SUMMARY OF TESTIMONY OF BOBBY G. TREECE
ON ISSUES 5 AND 6 (CABLE
OVERTENSIONING) AS LIMITED BY THE LICENSING
BOARD'S ORDER OF JUNE 8, 1984

DIRECT TESTIMONY OF
BOBBY G. TREECE
ON ISSUES 5 AND 6
(CABLE OVERTENSIONING),
AS LIMITED BY THE LICENSING BOARD'S
ORDER OF JUNE 8, 1984

Cable Pull Criteria

CABLE PULL REPORTS SUBMITTED FOR REVIEW
PITTSBURGH TESTING LABORATORY REPORT NUMBERS

These sketches are being sent to you for your analysis and comment, because our preliminary calculations for these installations indicate that the maximum allowable pulling tensions for the installed cables, based on Okonite's cable pulling criteria, may have been exceeded.

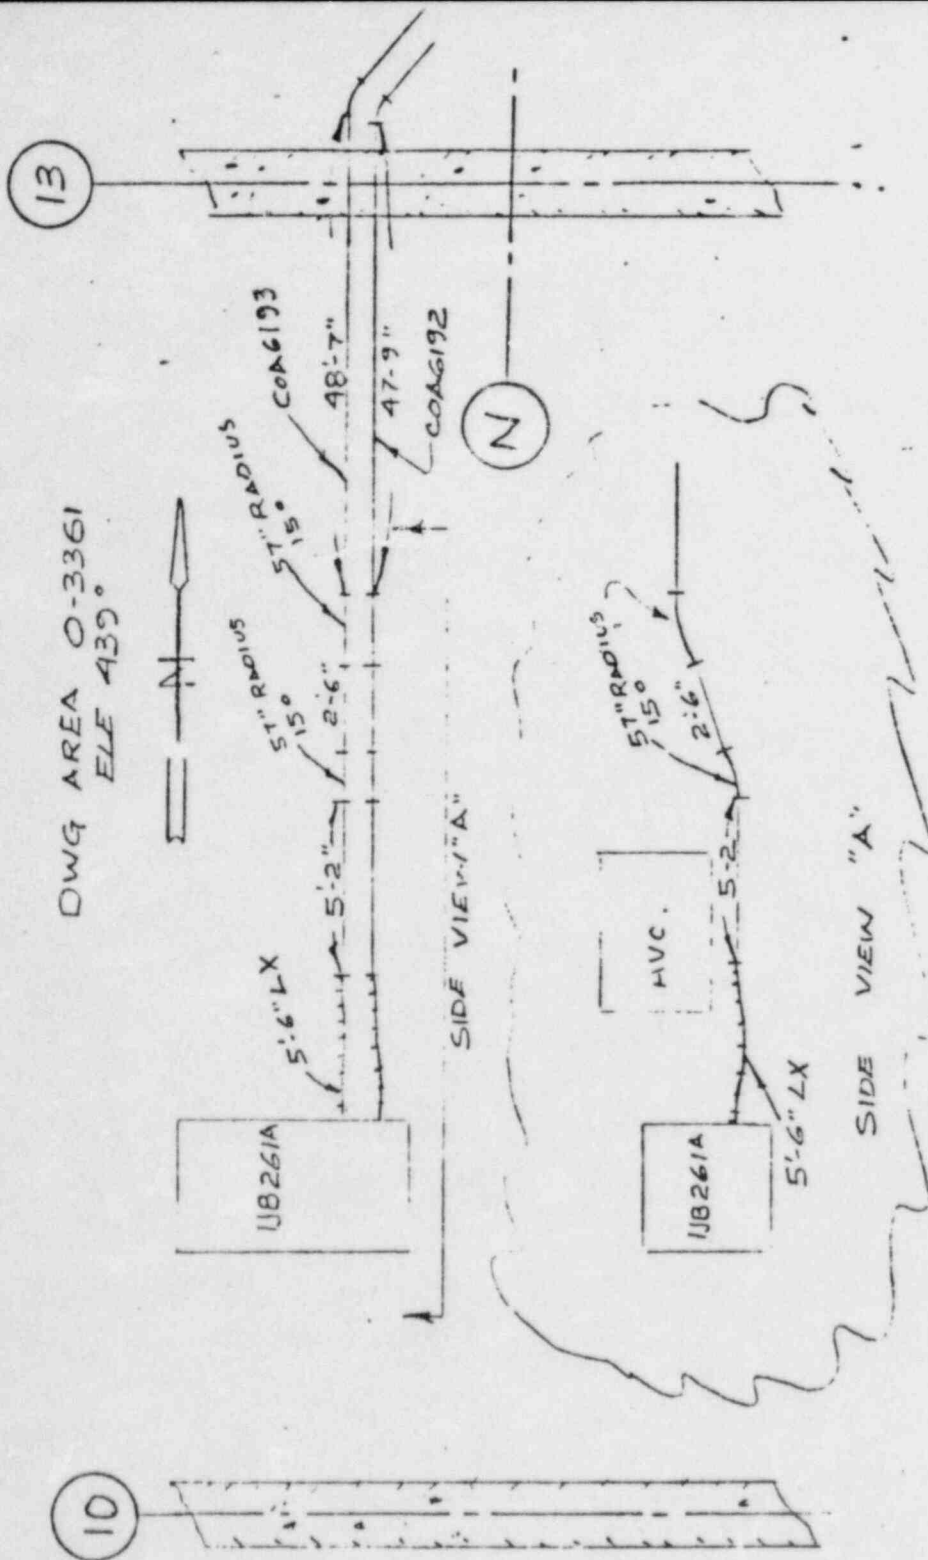
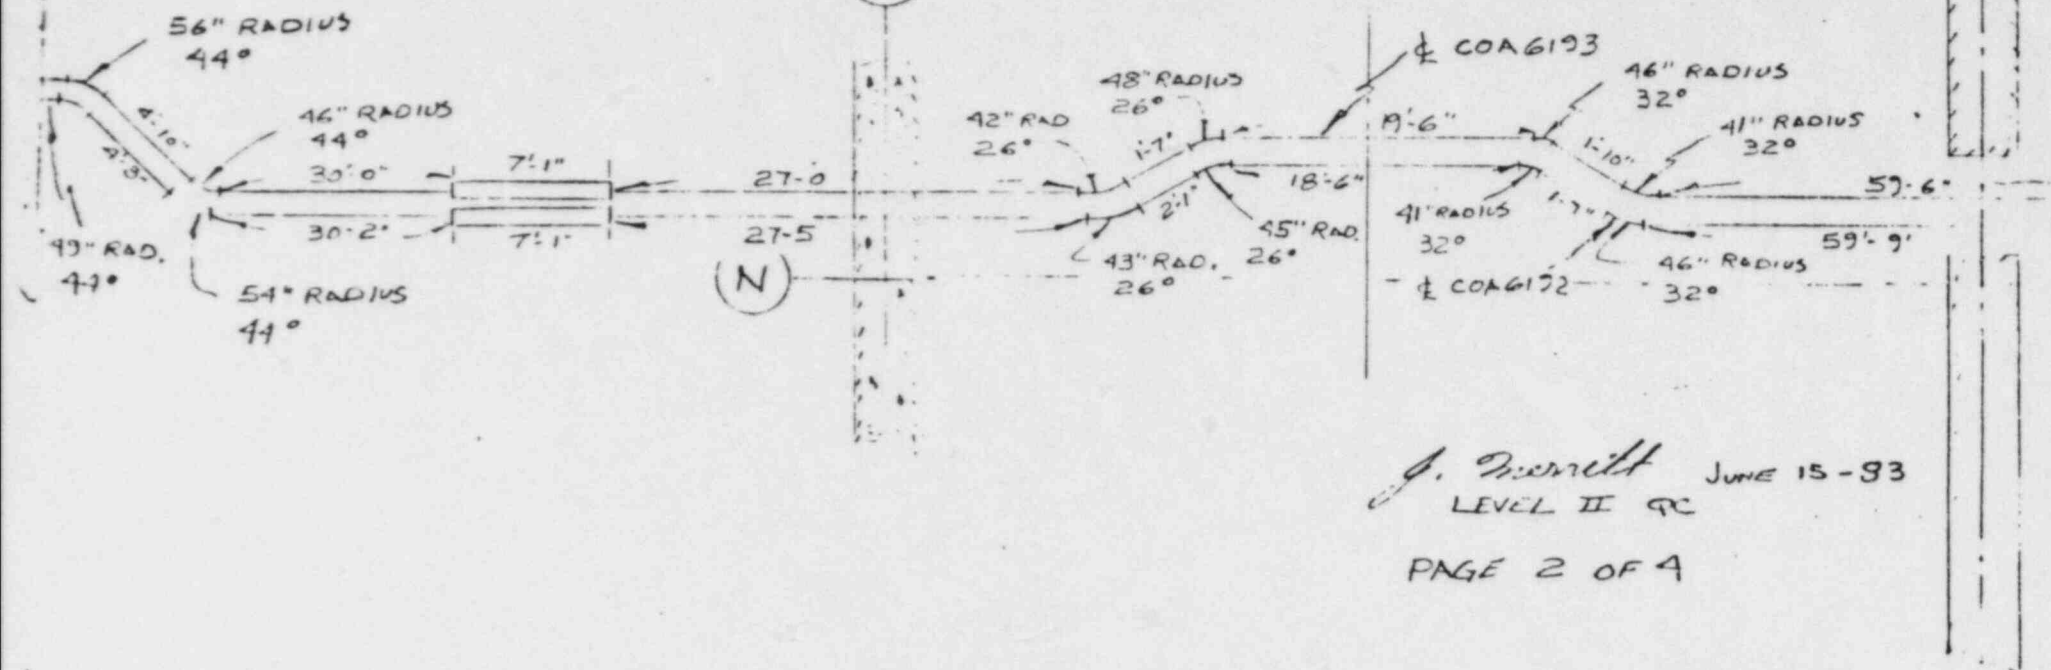
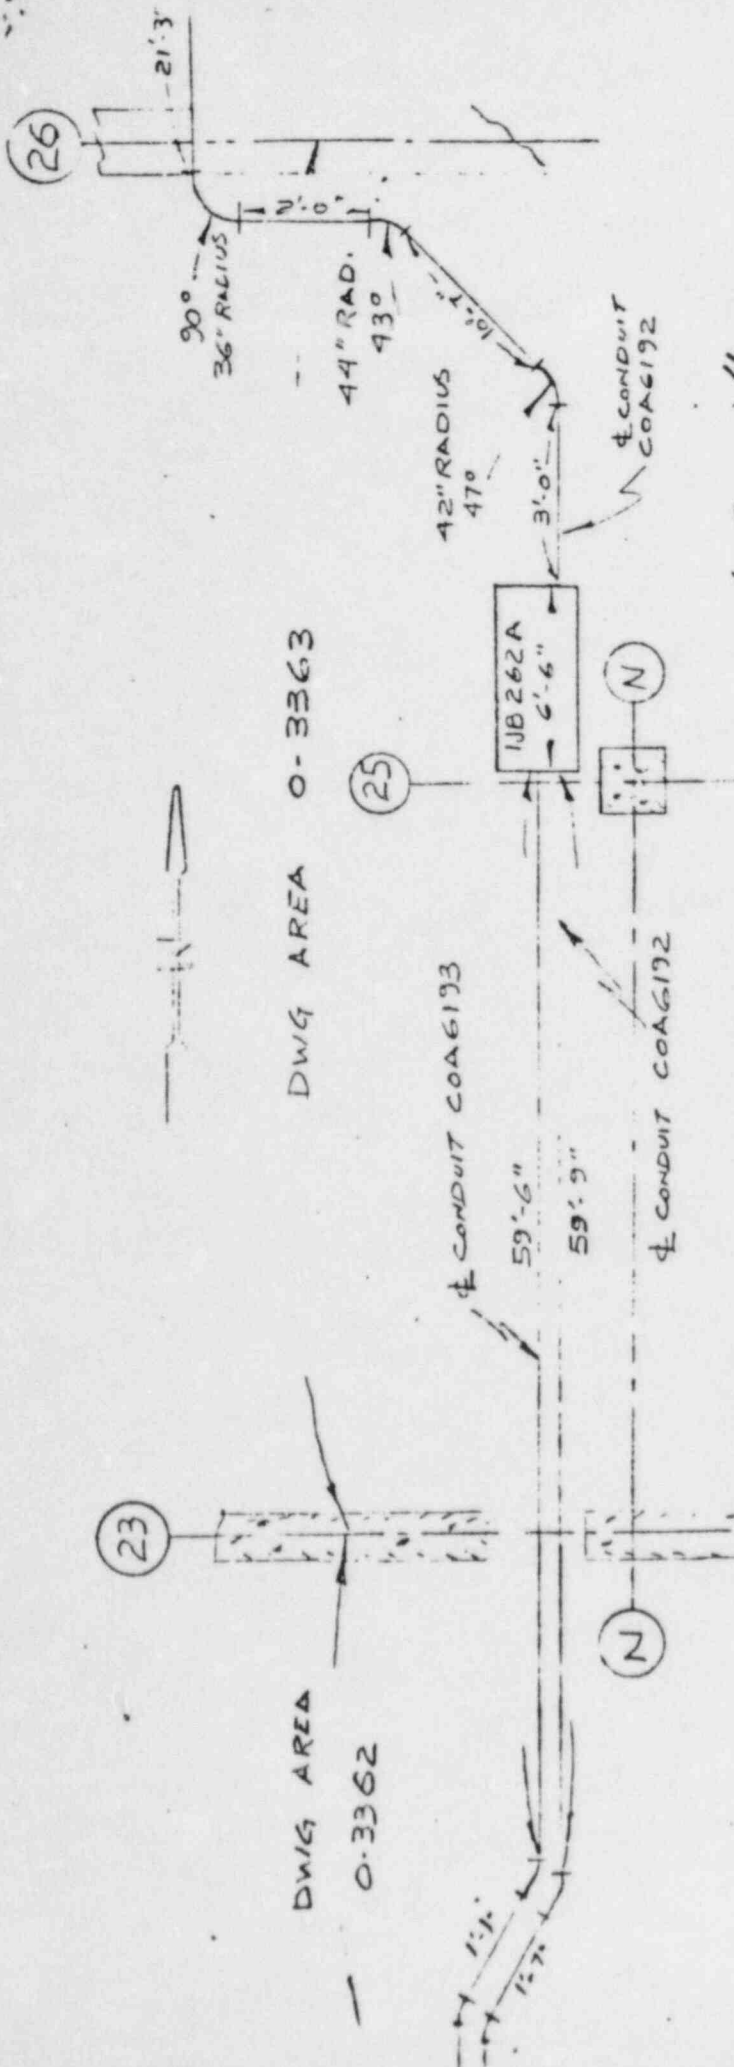
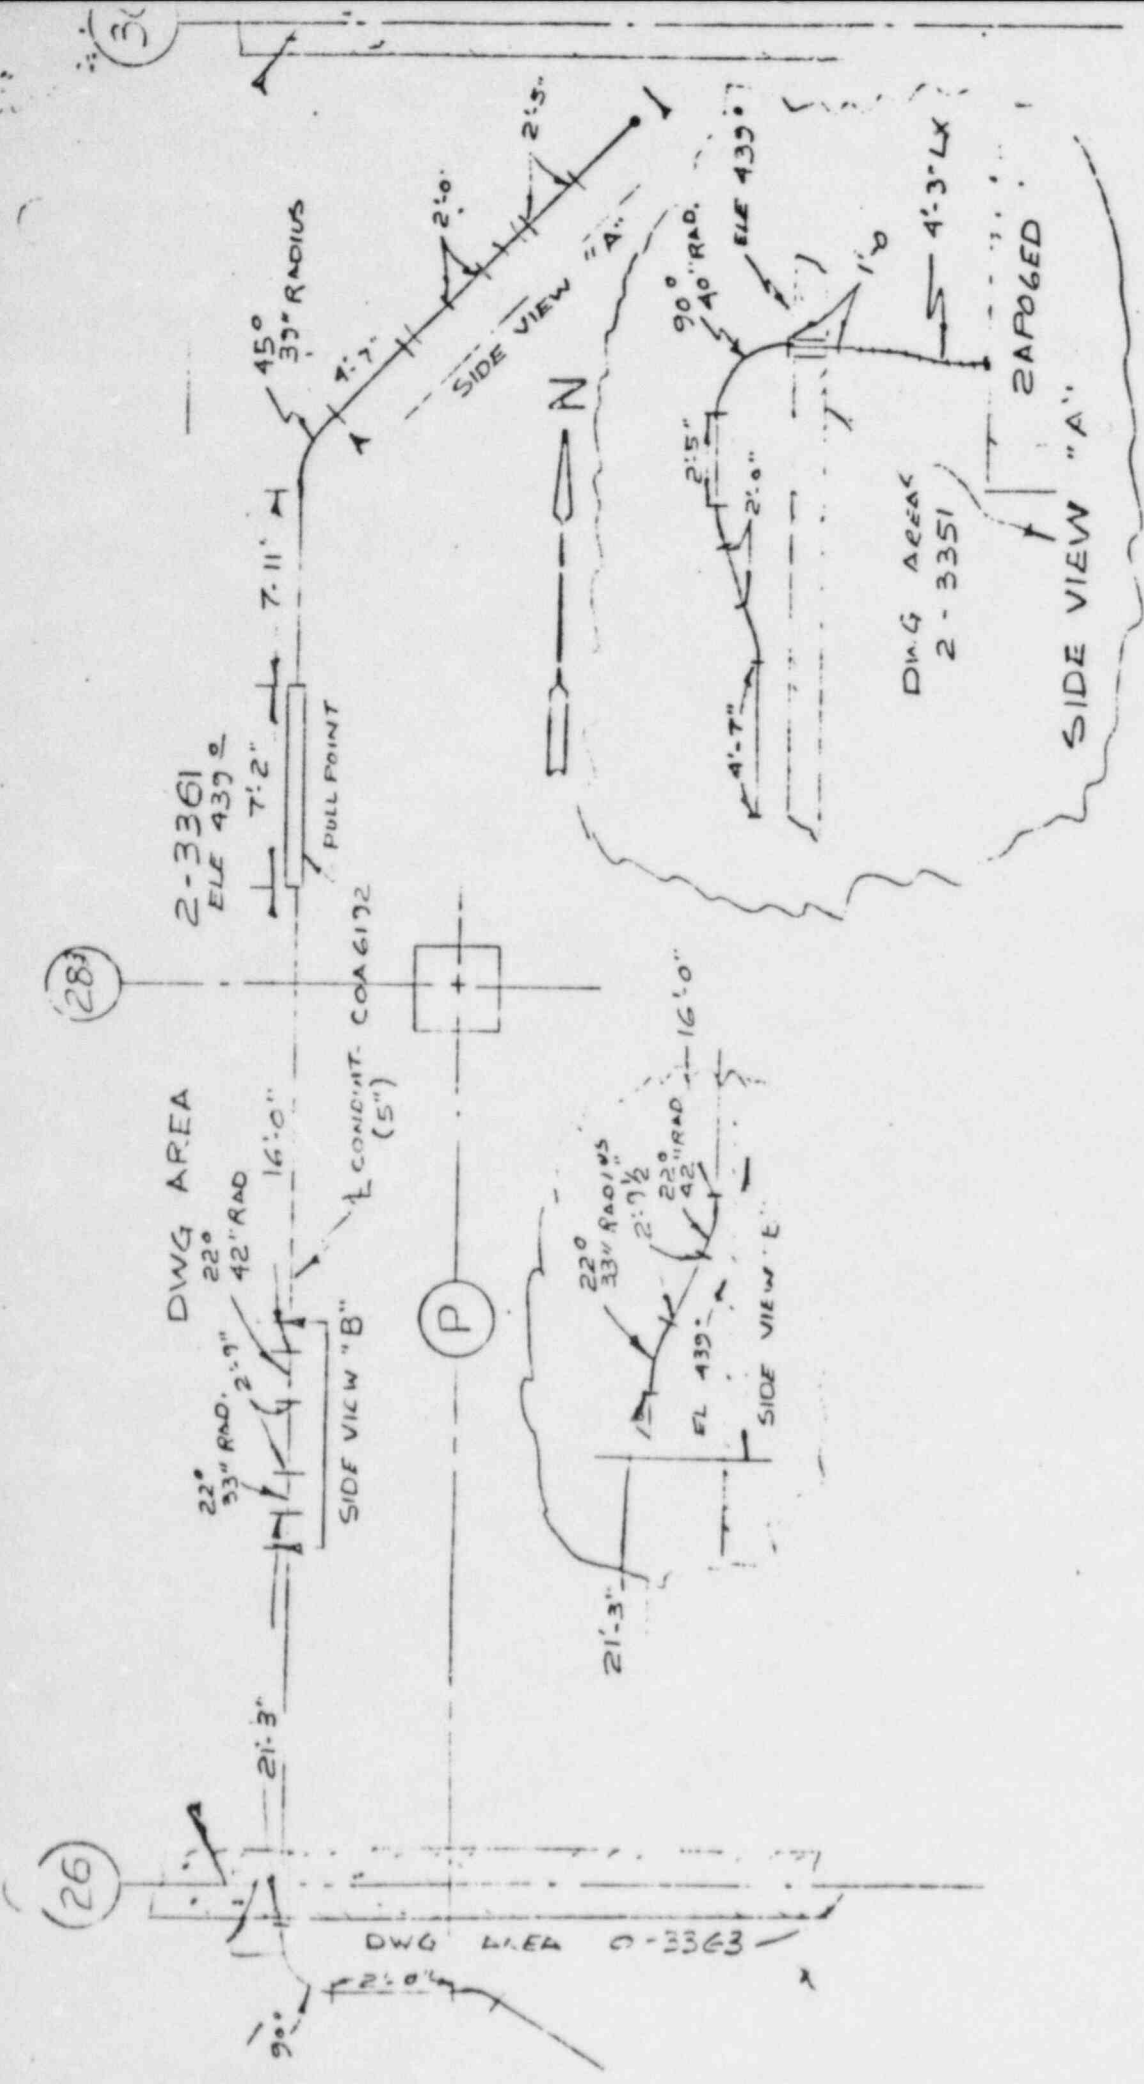
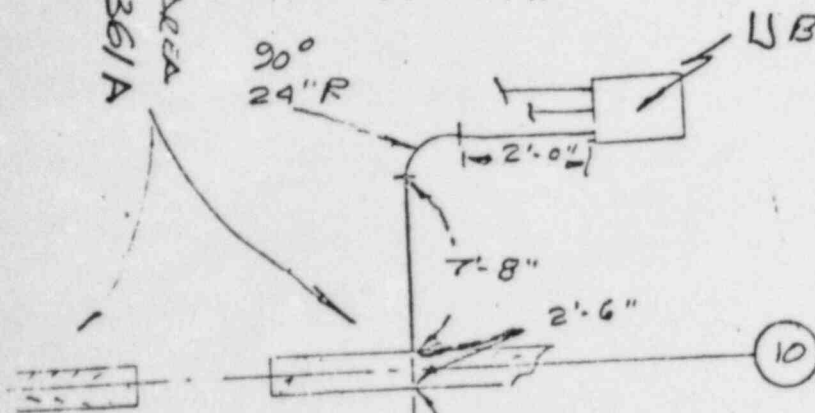
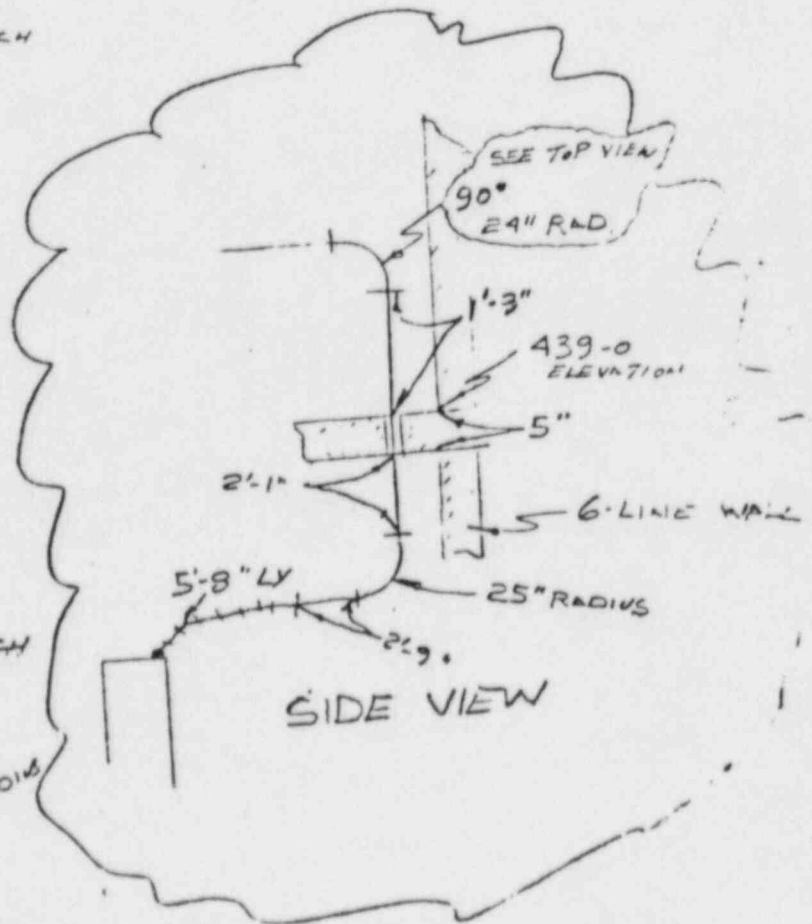
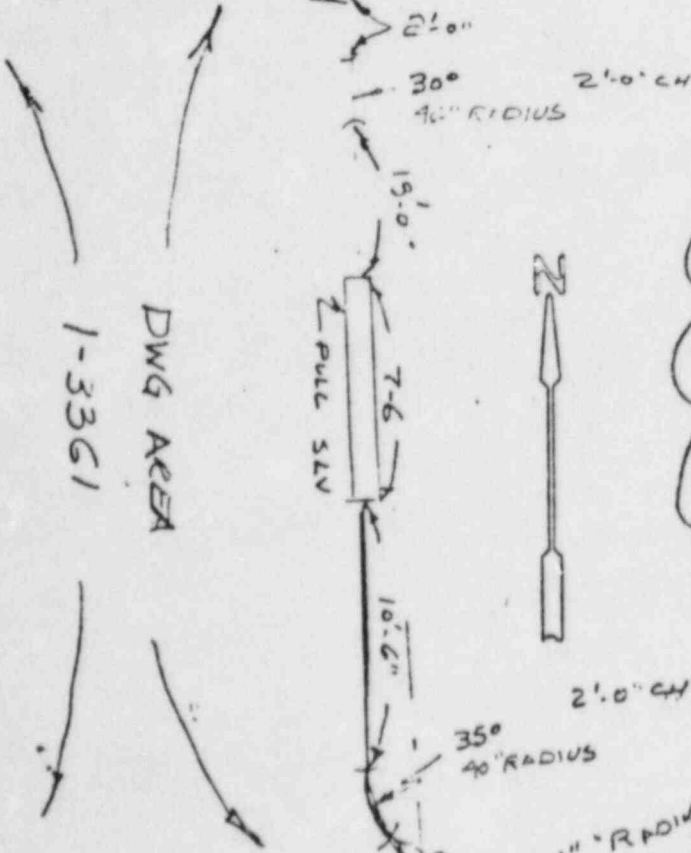
Attached are calculations for the cable pulls for the drawings submitted by you. Pulling from LJB261A to Gear in one continuous length provides excessively high pulling tension and sidewall pressures. This is caused by the excessive number of offsets located in this run. The total tension calculates out to 52,000 lbs. in this direction. The coefficient of friction actual was probably lower than 0.35 but in any case the allowable tension and sidewall pressures were exceeded by the wide margin. These calculations appear on pages 1 and 2 of the attached sheets.

If cable had been pulled from the gear to LJB261A, they would have reduced the total tension down to approximately 16,000 lbs. and a maximum sidewall pressure of 3226 lbs./ft. These values although extremely high are well below the pull in the other direction. It would have been helpful if the pulling crew had used a dynamometer to give us an idea what the actual tension was, but it is assumed they did not.

If the cable was pulled from LJB261A to gear it should be replaced because of the very high pulling tension and sidewall pressure that would have been experienced.

The cable is okay for use if it was pulled from the rear to 1JB261A since the calculations show pulling tension and sidewall pressure to be acceptable.
